New Albany Planning Commission Meeting Agenda
Monday, December 16, 2024 at 7:00 p.m.

New Albany Planning Commission
Monday, November 18, 2024 Meeting Minutes - DRAFT

**Planning Commission Staff Report
November 18, 2024 Meeting**

**Planning Commission Staff Report
November 18, 2024 Meeting**

REVISSED PORCH PLAN

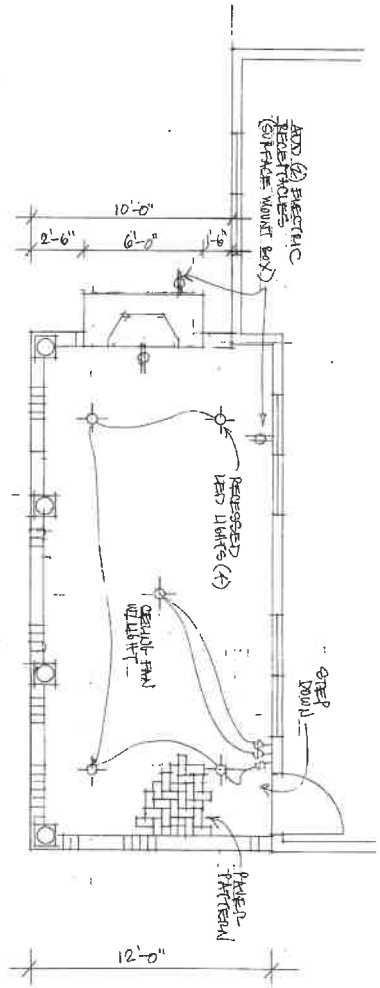
Since receiving the denial, circumstances affecting the subject property have substantially changed. The plan for the proposed porch has been revised to locate the proposed fireplace chimney (2 feet in depth) to the left side of the porch, instead of extending 2 feet into the back yard. *See* Revised Plan, attached as Exhibit C. Under the revised plan, the chimney will be brick, as the Commission requested. The original application incorrectly stated that “[t]he rear of the house is located 36.97’ from the rear lot line.” Exhibit A, p. 3 (unnumbered) at ¶ 3. This measurement did not take into account the 2’ recess in the exterior wall at the rear of the house where the covered porch would be located. The measurement from the rear lot line to the exterior rear wall of the house (where the porch would be located) is 38.97 feet. There is a 35-foot special rear yard setback. “Decks, patios, and screened porches may encroach a maximum of 6 feet into the minimum required rear yard setback.” Zoning Regulation E(6). “The Zoning text for the subdivision does say for all decks, patios and screen porches, so it’s covered or uncovered, we believe that this regulation would apply.” *See* excerpt of Sept. 16, 2024 Hearing Transcript, attached as Exhibit D, p. 4. Therefore, 3.97’ of the backyard is outside of the setback. The revised plan requests a variance of 2.03’.

Courtyards at Haines Creek

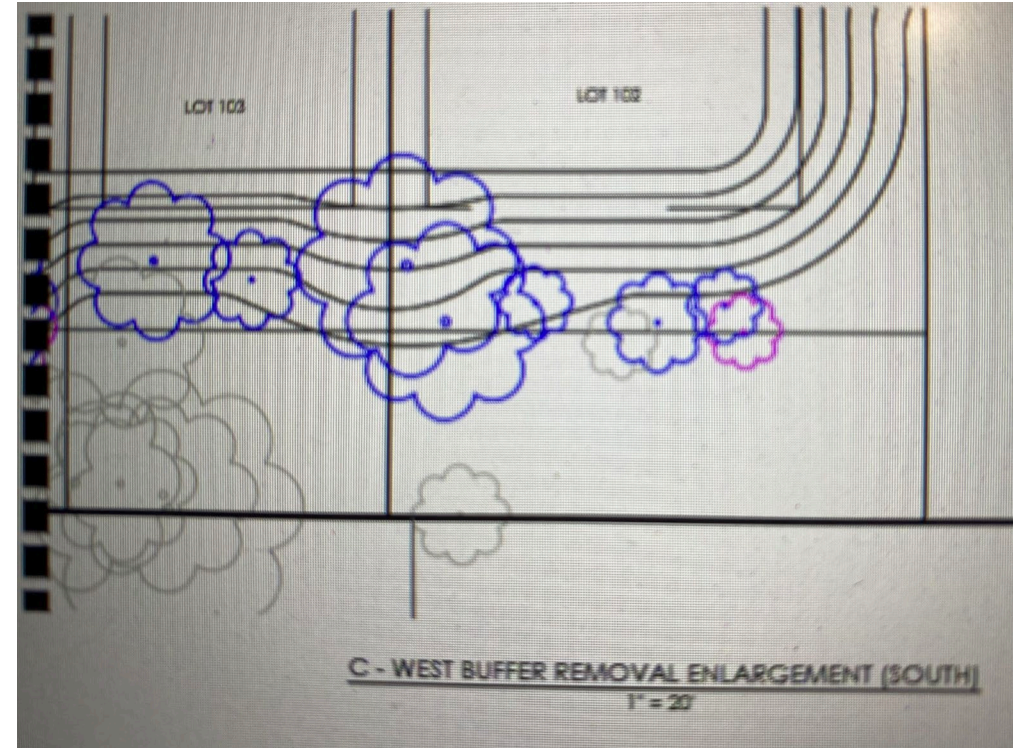
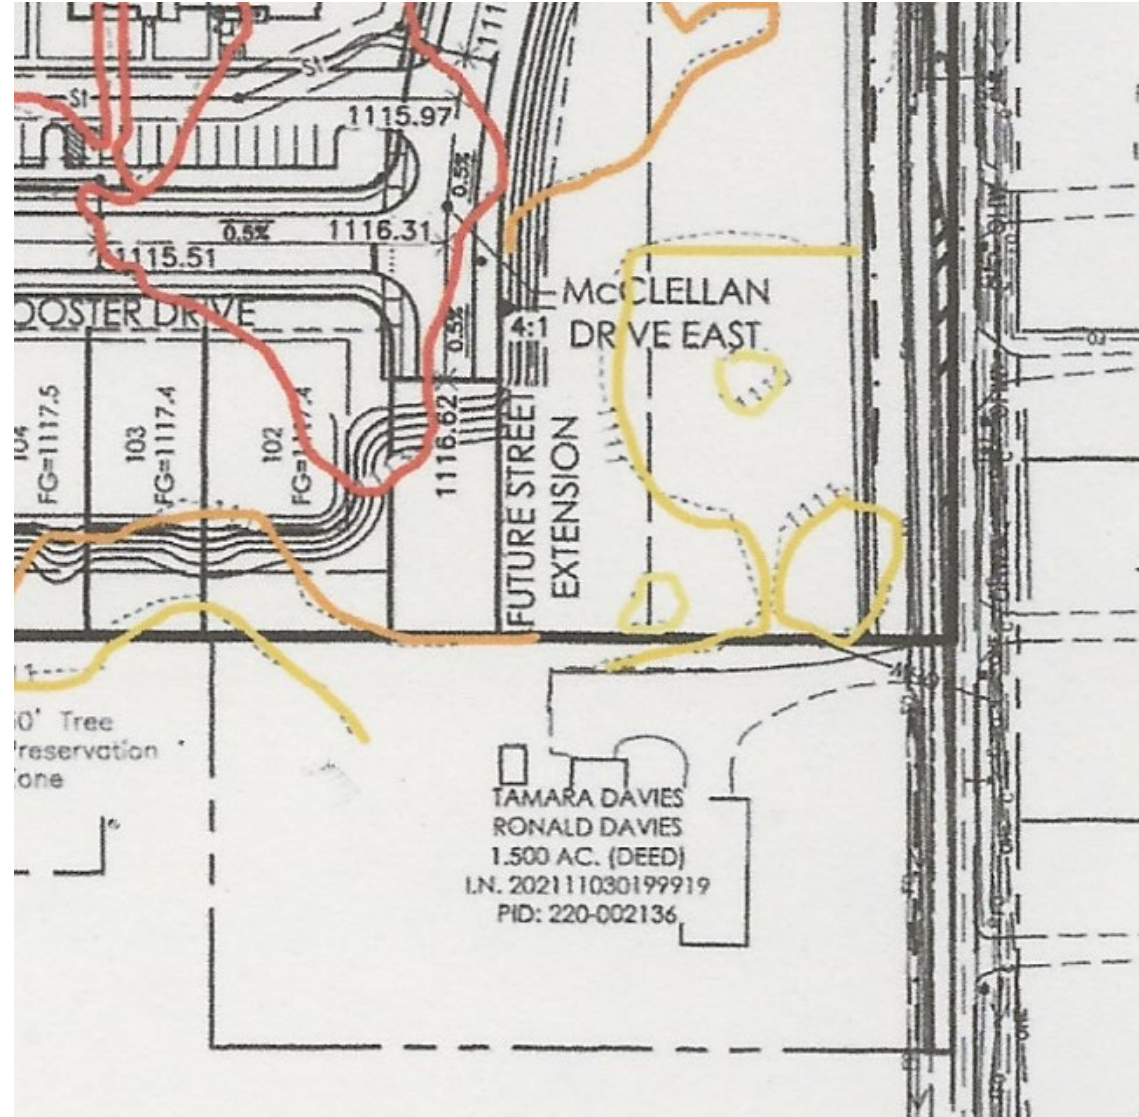
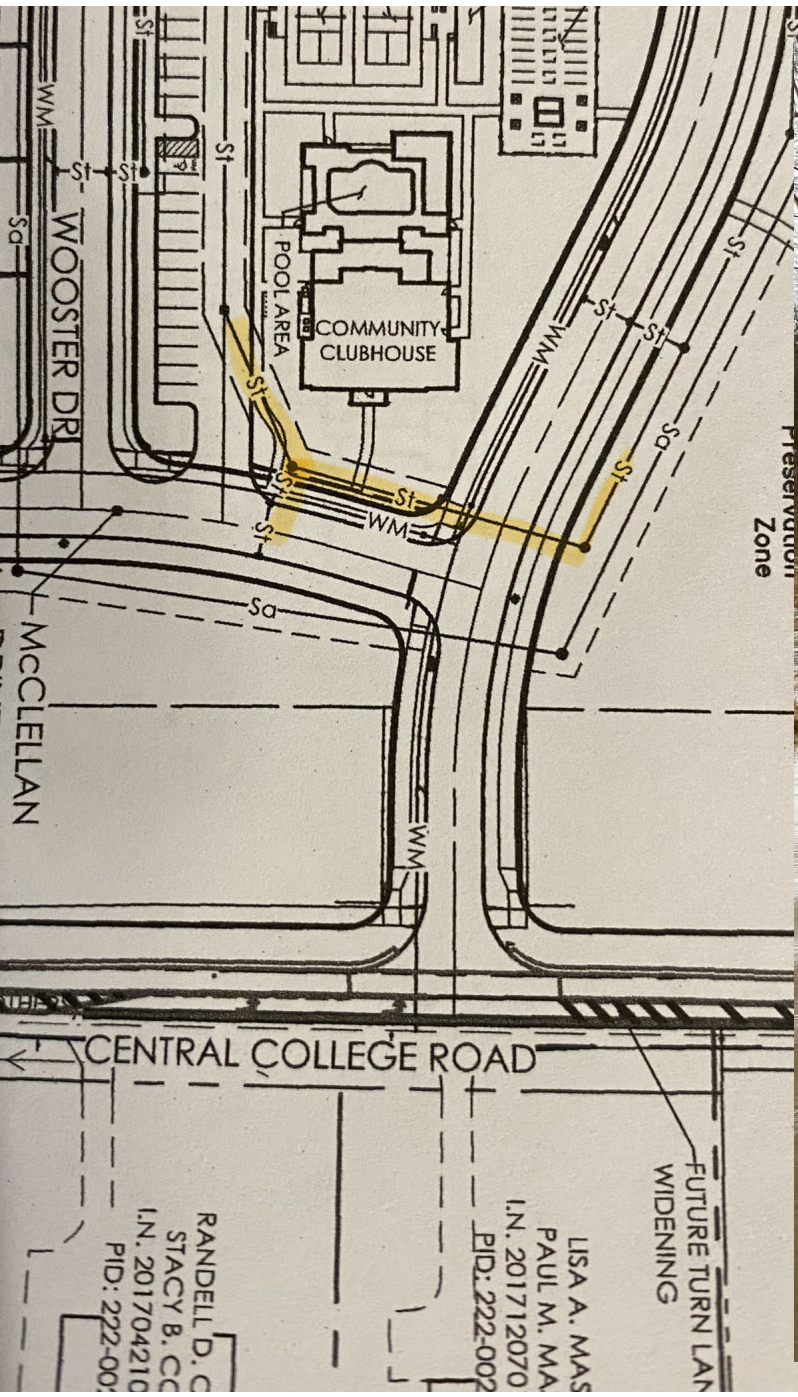
The base of the home on lot# 102 will be 7 feet higher than the home at 8238 Central College

The road stub will be 7 feet above grade for our home at 8238 Central College Rd. This disparity negatively effects the home's value.

Who has measured current drainage?

Planning Manager Mayer stated that drainage was presented and reviewed with the final development plan. The city's engineer will review and approve the storm water plan.
